Sub: Modification Sheet No. RDSO/2022/EL/MS/0486 (Rev. '0') dtd. 21.02.2022 for the modification to ensure continuity of HOG Converters' feed to the train from working loco through dead loco in WAP5/WAP7 class of 3-phase HOG compliant electric locomotives.

MODIFICATION SHEET NO. RDSO/2022/EL/MS/486 (Rev. '0') dated 21/03/2022

Modification to ensure continuity of HOG Converters' feed to the train from working loco through dead loco in WAP5/WAP7 class of 3-phase HOG compliant electric locomotives.

Figure – 1

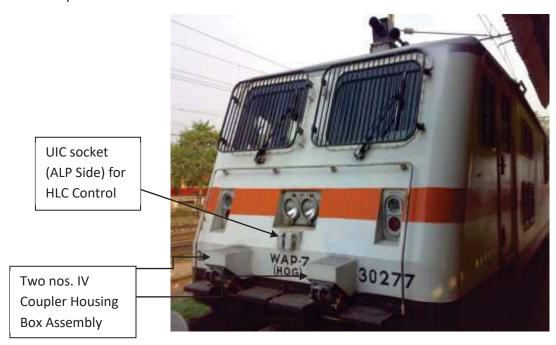
- elaborated in RDSO/2018/EL/MS/0468, Rev. '0' dtd. 06.02.2018. Sockets of IV couplers and UIC coupler have been provided in either side of the loco as shown in Figure-1.
- 2.2 When WAP5/WAP7 Locomotive fails on line during train operation, assistant locomotive is connected to the front of failed (dead) loco to haul the train. In this situation, HOG power from HLCs of leading loco can't be transmitted to Power Car through Dead Engine (trailing loco) even after connecting HOG enabled loco (leading loco) as required HOG control and power connections are not made between the two locomotives.

Figure – 3: Infringement of loco body to the Ratchet Grip

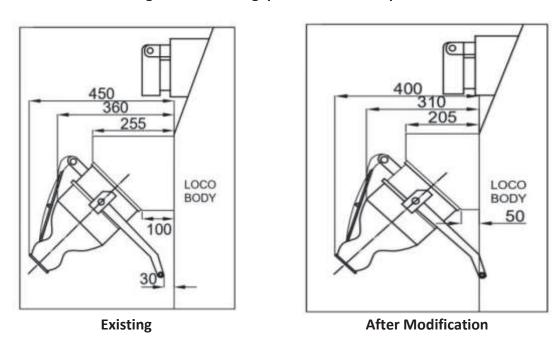
4.1 It is to be mentioned that there is a very less gap between the two existing IV coupler Housing Box assembly when two WAP5/WAP7 locomotives fitted with Hotel Load Converters/Composite Converters are connected in MU. Due to fewer gap, hinged cover of any IV coupler housing box assembly is not possible to open completely which may be seen in Figure–2. CLW has recently reviewed the drawing of IV coupler housing and reduced the critical dimensions vide CLW drawing No. CDD-HL-P73-085, Alt. 2 dtd. 06.02.2021 (Annexure-1). It has been observed that there is no clearance between Ratchet grip handle and loco body with the CLW modified drawing and due to infringement with loco body, proper connection cannot be established. This infringement may be seen in Figure – 3.

Figure – 4: Sketch of the IV Coupler Housing Box after modification

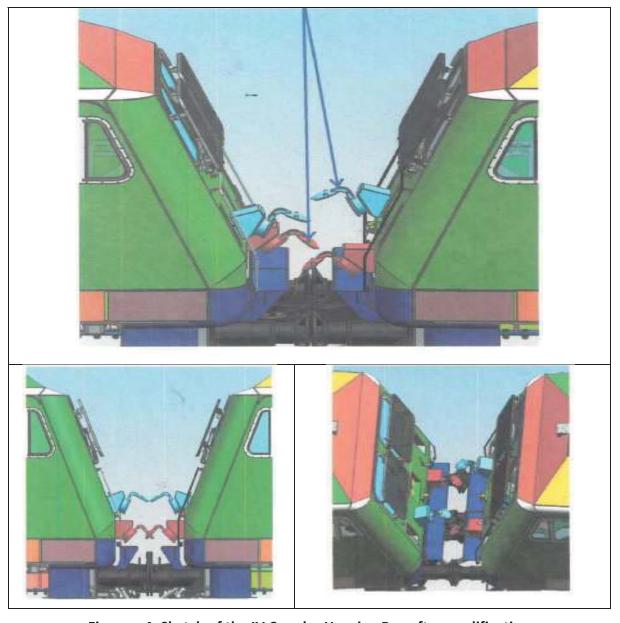
ALP side IV Coupler Socket Housing Box shall be shifted upward as indicated in the CLW drawing No. SKETCH-28/01/22 enclosed as Annexure-2. LP side IV Coupler Socket Housing Box shall be retained at its original position. When two locos are connected back-to-back, ALP side IVC socket housing box of one loco will face LP side IVC socket housing box of the second loco. Since the ALP side IVC socket housing box is shifted upward, the two facing IVC housing box (ALP & LP side) will not be at the same level. Hence the limitation in the existing system as mentioned in Para-4.0 above will be eliminated and ratchet grip handle with hinged cover can be opened completely without infringement. This scheme will be able to feed HLC power from leading loco to train. Sketches of the two coupled locomotives with modified ALP side IV Coupler Housing Box have been shown in the Figure – 4 below.

Figure – 6

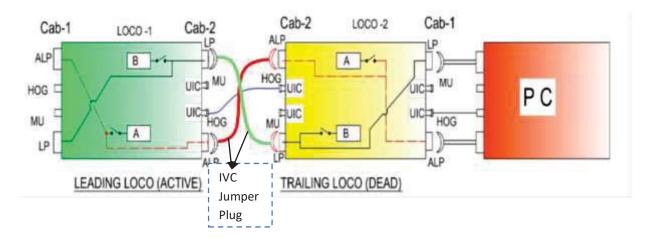
- 5.4 Connection of IVC Jumper Plug and UIC couplers between active loco and dead loco and further to Power Car will be look like the sketch shown in Figure 6.

- (i) Connect one IVC Jumper Plug (having plug assembly at both ends) between active loco (leading) LP side IVC housing socket assembly to dead loco (trailing) LP side IVC housing socket assembly.

- (ii) Connect another IVC Jumper Plug (having plug assembly at both ends) between active loco (leading) ALP-side IVC housing socket assembly to dead loco (trailing) ALP-side IVC housing socket assembly.

- (iii) Connect 13-Pin UIC Coupler Jumper (Male Male) between active loco (leading) ALP-side UIC socket to dead loco (trailing) ALP-side UIC.
- (iv) Trip HOTEL load MCB 129.2 in SB-2 of dead locomotive.

- (v) Trip MCBs (if available) on both HLC Cubicles of dead locomotive.
- (vi) Keep IV Couplers and UIC Couplers connected between dead locomotive and Power car as it is.
